**THE NATIONAL GRID COMPANY plc**  
**GRID CODE REVIEW PANEL**  
**GRID CODE PROVISIONS FOR**  
**HIGH VOLTAGE DIRECT CURRENT (HVDC) INTERCONNECTORS**

**1. Introduction**

- 1.1. This paper proposes the inclusion of requirements in the Grid Code of provisions relating to the connection to the NGC Transmission System of HVDC interconnectors. These proposals have been prompted by recent experience on new HVDC interconnectors across the United Kingdom. It outlines the areas considered for inclusion and the resulting changes that would need to be reflected in the Grid Code. They would also be consistent with the proposed amendments to European Union Directive 96/92/EC (commonly known as the Internal Market in Electricity (IME Directive) and the proposed Regulations.

Figure 2

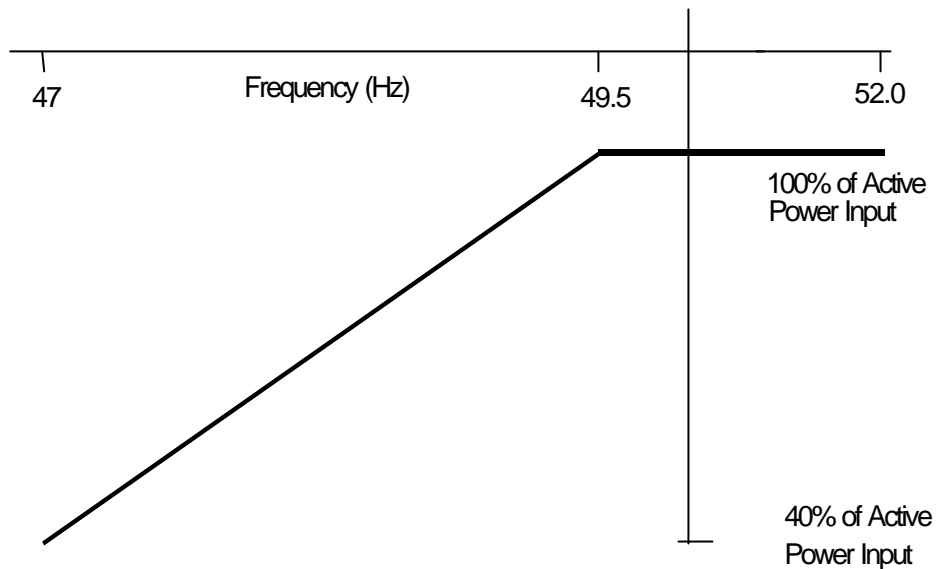
- (b) continuously maintaining constant Active Power input (i.e., when operating in a mode analogous to Demand) from the NGC Transmission System (or User System in the case of an Embedded DC Converter) for System Frequency changes within the range 49.5 to 52.0 Hz as shown in Figure 2.

- (c) maintaining its Active Power input (i.e., when operating in a mode analogous to Demand) from the NGC Transmission System (or User System in the case of an Embedded DC Converter) at a level not greater than the figure determined by the linear relationship shown in Figure 2 for System Frequency changes within the range 49.5 to 47 Hz, such that if the System Frequency drops to 47 Hz the Active Power input decreases by more than 60%.

Figure CC.A.3.1 - Minimum Frequency Response Requirement Profile

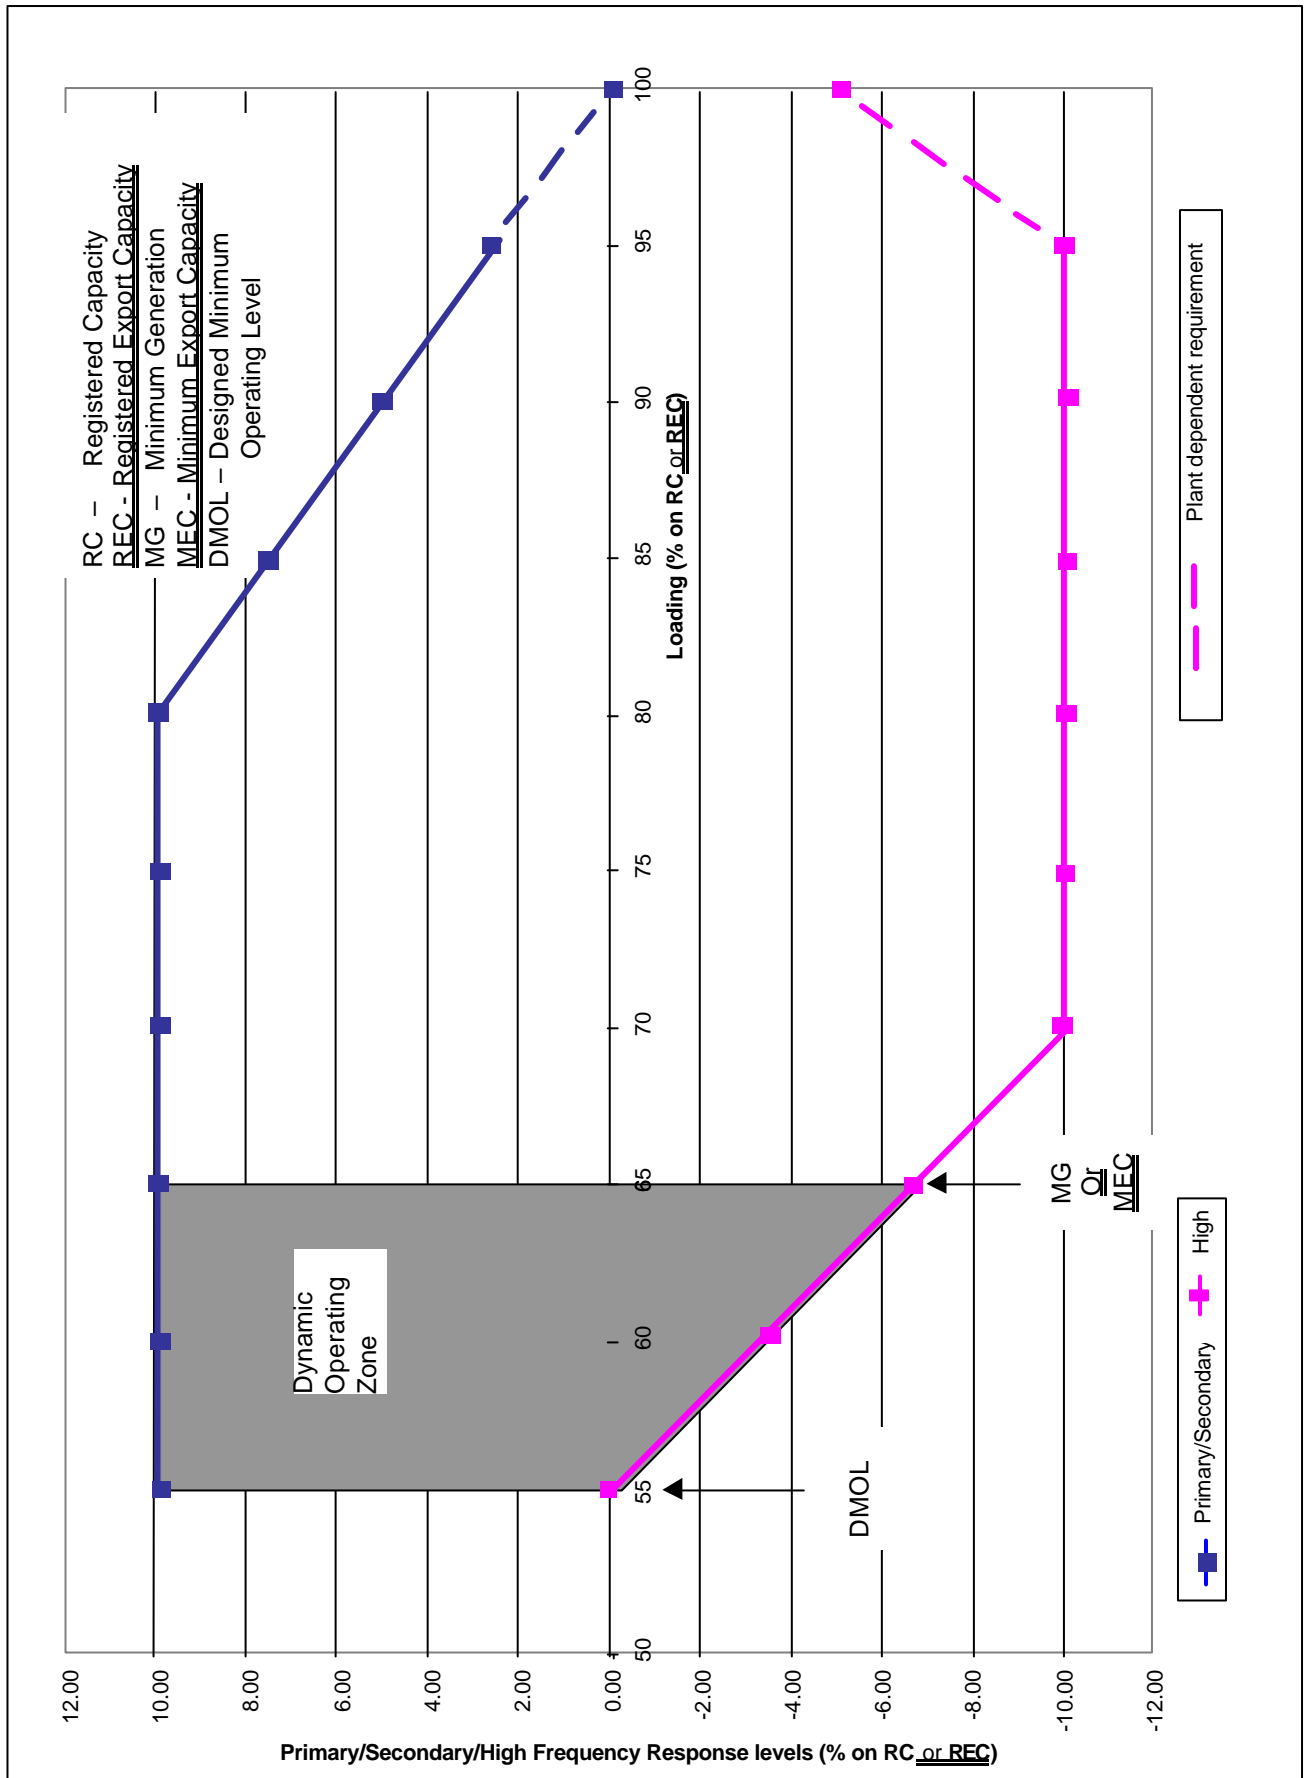
Figure CC.A.3.1 shows the minimum frequency response requirement profile diagrammatically for a 0.5 Hz change in **Frequency**. The percentage response capabilities and loading levels are defined on the basis of the **Registered Capacity** of the **Generating Unit** or **CCGT Module** (or **Registered Export Capacity** of the **DC Converter**, as the case may be). Each **Generating Unit** ~~and/or~~, **CCGT Module** or **DC Converter** must be capable of operating in a manner to provide frequency response at least to the solid boundaries shown in the figure. If the frequency response capability falls within the solid boundaries, the **Generating Unit** ~~or~~, **CCGT Module** or **DC Converter** is providing response below the minimum requirement which is not acceptable. Nothing in this appendix is intended to prevent a **Generating Unit** ~~or~~, **CCGT Module** or **DC Converter** from being designed to deliver a frequency response in excess of the identified minimum requirement.

Each **Generating Unit** ~~and/or~~, **CCGT Module** or DC Converter must be capable of providing some response, in keeping with its specific operational characteristics, when operating between 95% to 100% of **Registered Capacity** (or Registered Export Capacity, as the case may be) as illustrated by the dotted lines in Figure CC.A.3.1.

At the **Minimum Generation** level, each **Generating Unit** and/or **CCGT Module** is required to provide high and low frequency response depending on the **System Frequency** conditions. At the **Minimum Export Capacity** level, each **DC Converter** is required to provide high and low frequency response depending on the **System Frequency** conditions. Where the **Frequency** is high, the **Active Power** output is therefore expected to fall below the **Minimum Generation** (or **Minimum Export Capacity, as the case may be**) level.

The **Designed Minimum Operating Level** is the output at which a **Generating Unit** ~~and/or~~, **CCGT Module** or DC Converter has no **High Frequency Response** capability. It may be less than, but must not be more than, 55% of the **Registered Capacity** (or **Registered Export Capacity, as the case may be**). This implies that a **Generating Unit** ~~or~~, **CCGT Module** or DC Converter is not obliged to reduce its output to below this level unless the **Frequency** is at or above 50.5 Hz (cf BC3.7).

In Figure CC.A.3.1, the terms **Registered Capacity (RC)** and **Minimum Generation (MG)** apply to **Generating Units** and/or **CCGT Modules**. The terms **Registered Export Capacity (REC)** and **Minimum Export Capacity (MEC)** apply to **DC Converters**. The term **Designed Minimum Operating Level (DMOL)** applies to all.

Figure CC.A.3.2 - Interpretation of Primary and Secondary Response Values

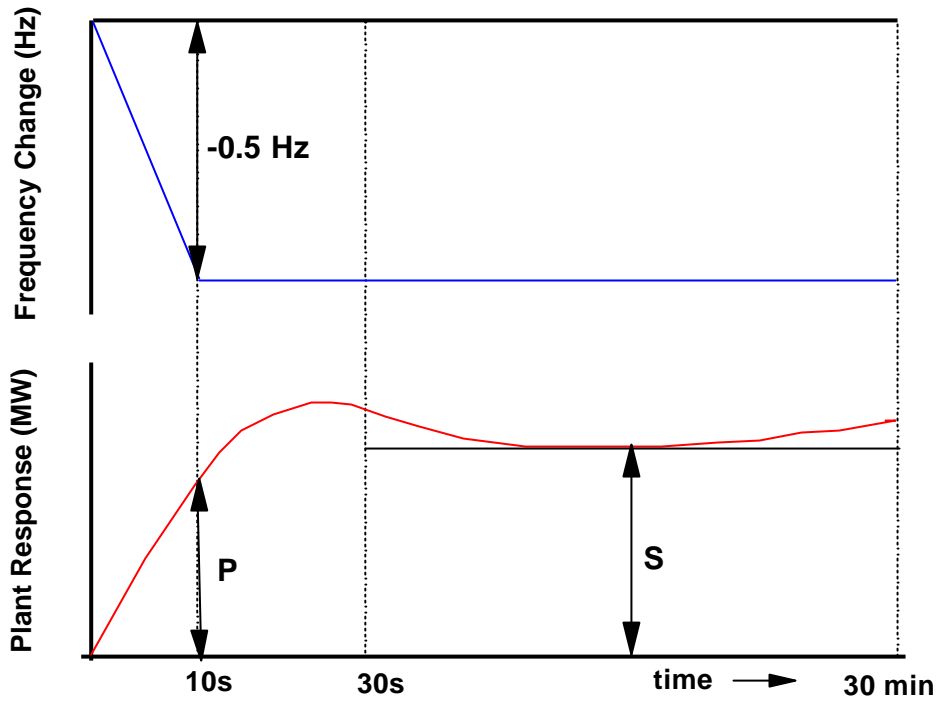
The **Primary Response** capability (P) of a **Generating Unit** ~~or a~~, **CCGT Module** or DC Converter is the minimum increase in **Active Power** output between 10 and 30 seconds after the start of the ramp injection as illustrated diagrammatically in Figure CC.A.3.2.

The **Secondary Response** capability (S) of a **Generating Unit** ~~or a~~, **CCGT Module** or DC Converter is the minimum increase in **Active Power** output between 30 seconds and 30 minutes after the start of the ramp injection as illustrated diagrammatically in Figure CC.A.3.2.

Figure CC.A.3.3 - Interpretation of High Frequency Response Values

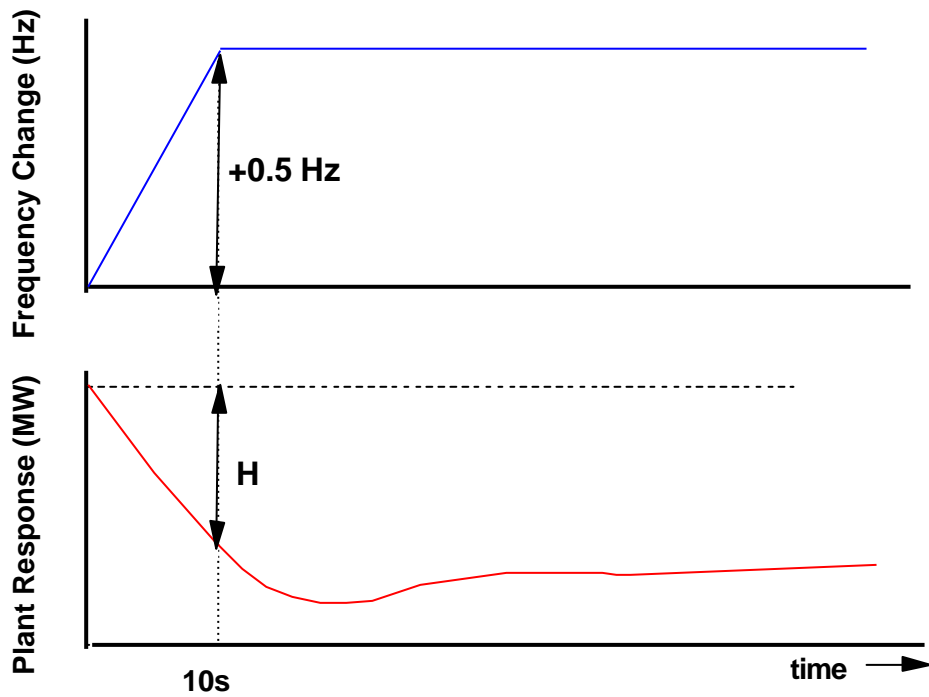
The **High Frequency Response** capability (H) of a **Generating Unit** ~~or a~~, **CCGT Module** or DC Converter is the decrease in **Active Power** output provided 10 seconds after the start of the ramp injection and sustained thereafter as illustrated diagrammatically in Figure CC.A.3.3.
